**STATE OF TENNESSEE  
DEPARTMENT OF TRANSPORTATION  
DESIGN DIVISION**

**INSTRUCTIONAL BULLETIN NO. 13-08**

**Regarding New and Revised Standard Drawings**

**Effective for the July 12<sup>th</sup> letting (May 1<sup>st</sup> turn-in),** the following Standard Drawings are new or revised and Section V of the Design Guidelines is revised for this update.

**TYPICAL PLAN VIEW OF ROUNDABOUT**

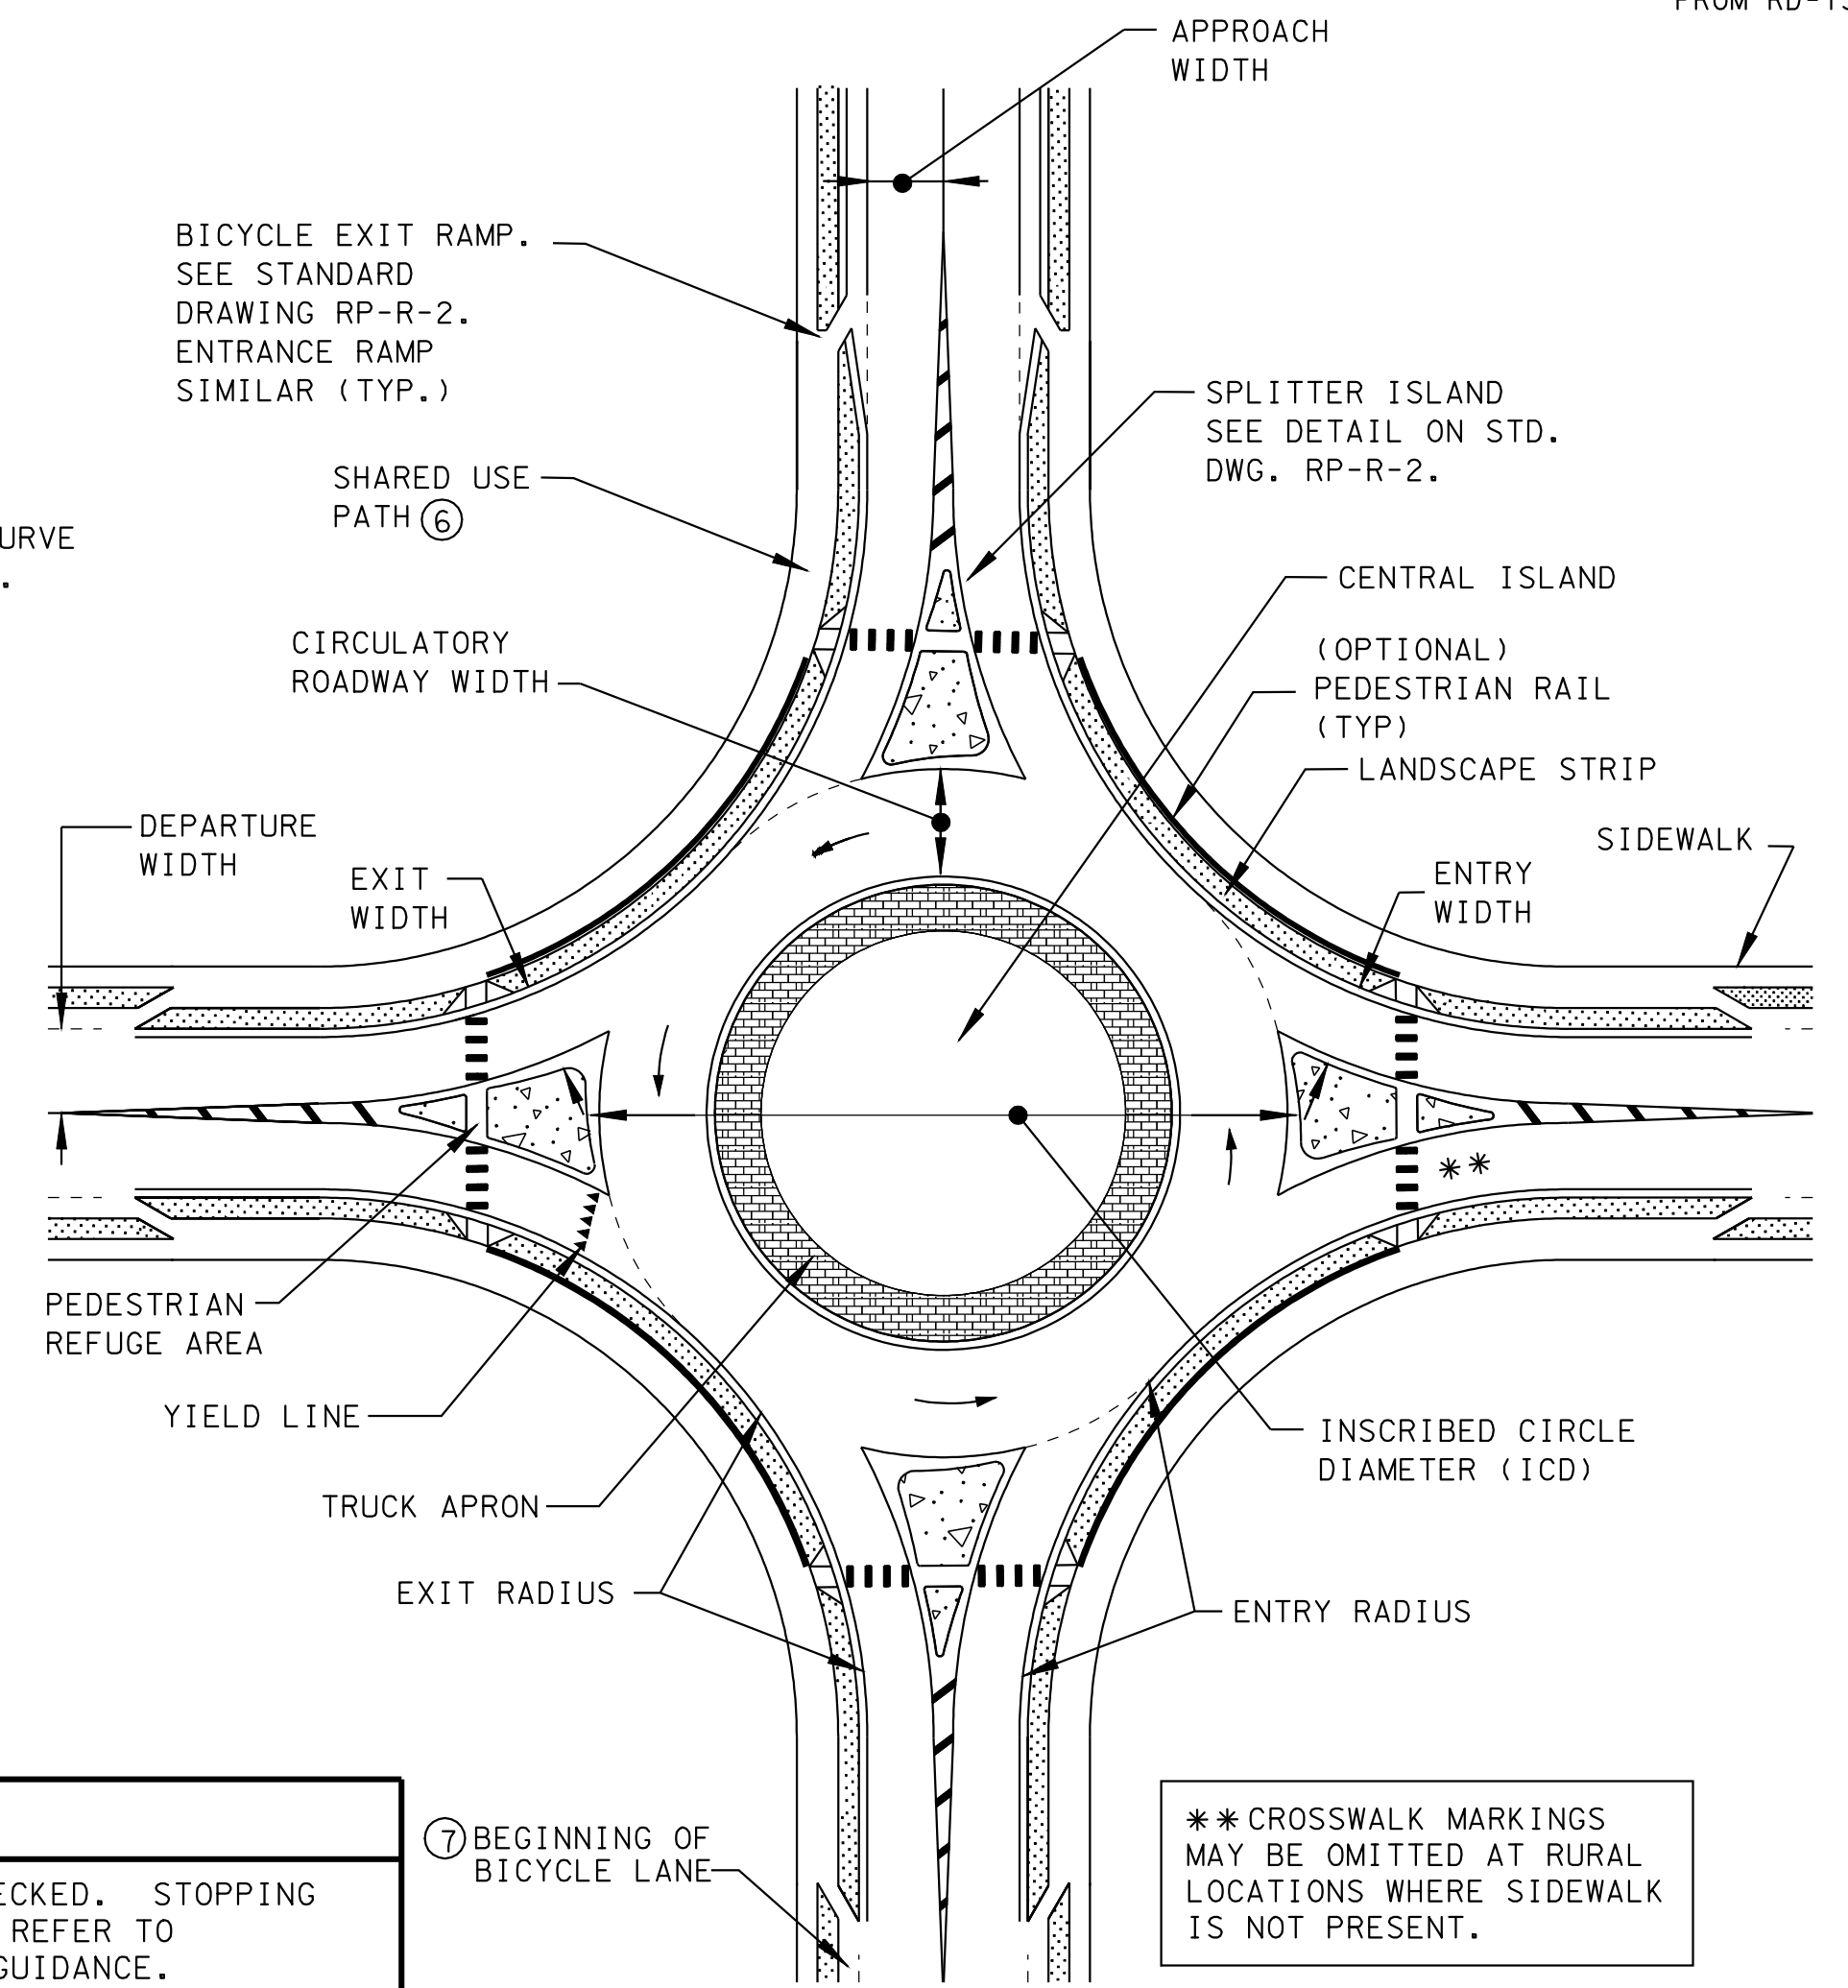
REV. 2-1-12: ADDED OPTIONAL PEDESTRIAN RAIL.  
 REV. 6-15-12: RENAMED SHEET FROM RD-TS-9. ADDED NOTE (M)

**DESIGN STANDARDS FOR MULTI-LANE URBAN AND RURAL ROUNDABOUTS**

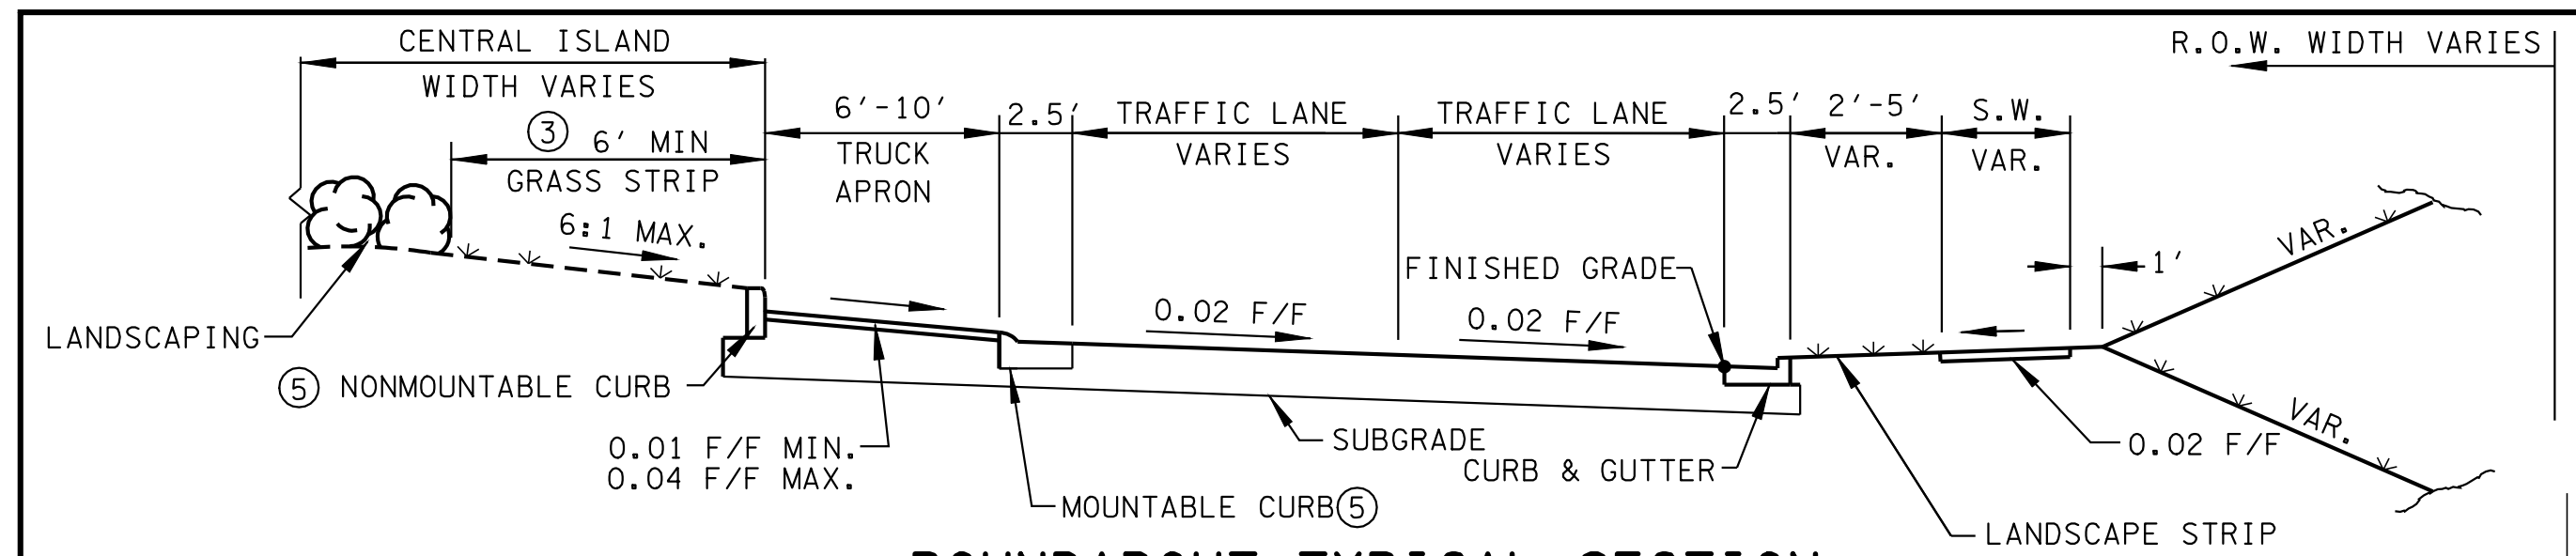
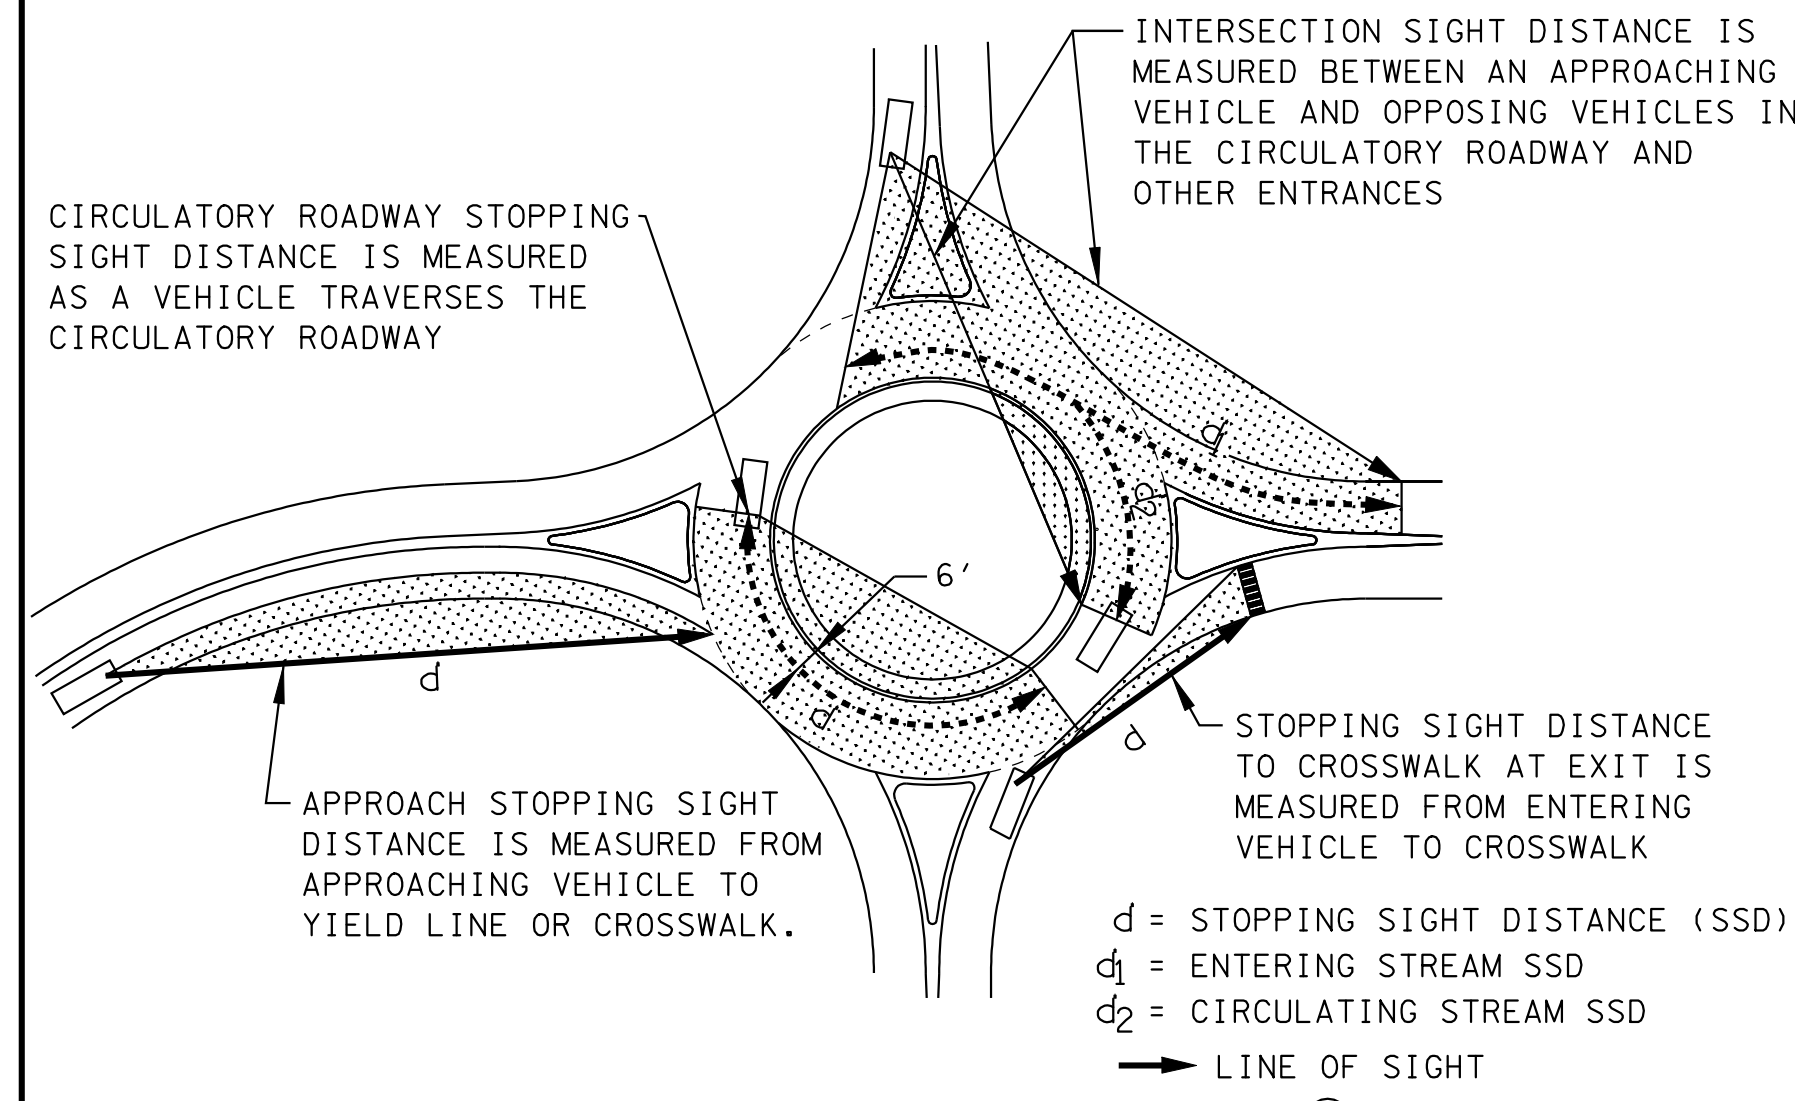
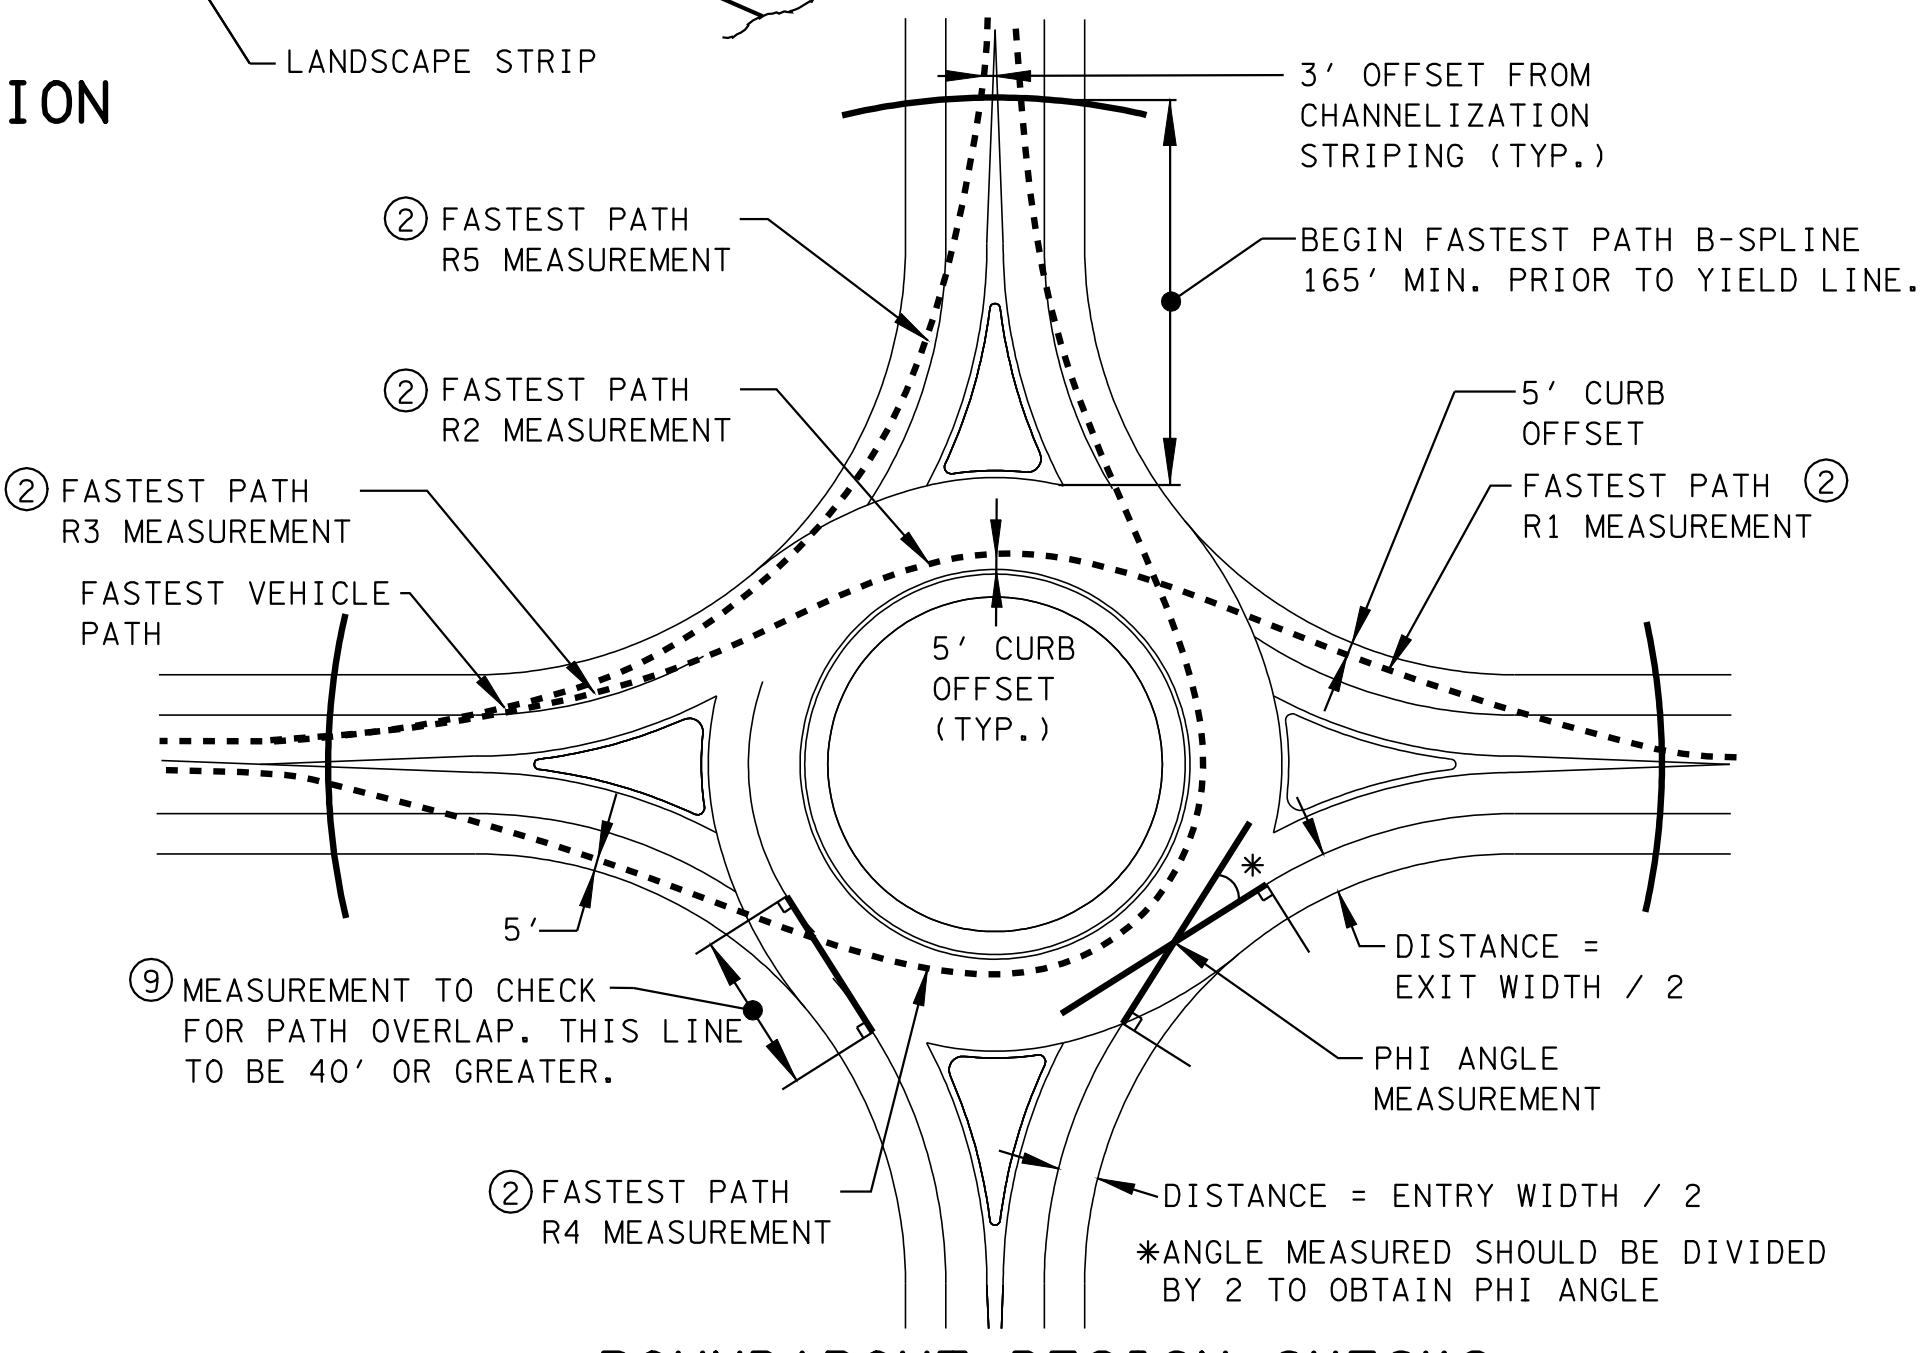
REV. 2-1-12: ADDED OPTIONAL PEDESTRIAN RAIL.  
 REV. 6-15-12: RENAMED SHEET FROM RD-TS-10. ADDED NOTE (M)
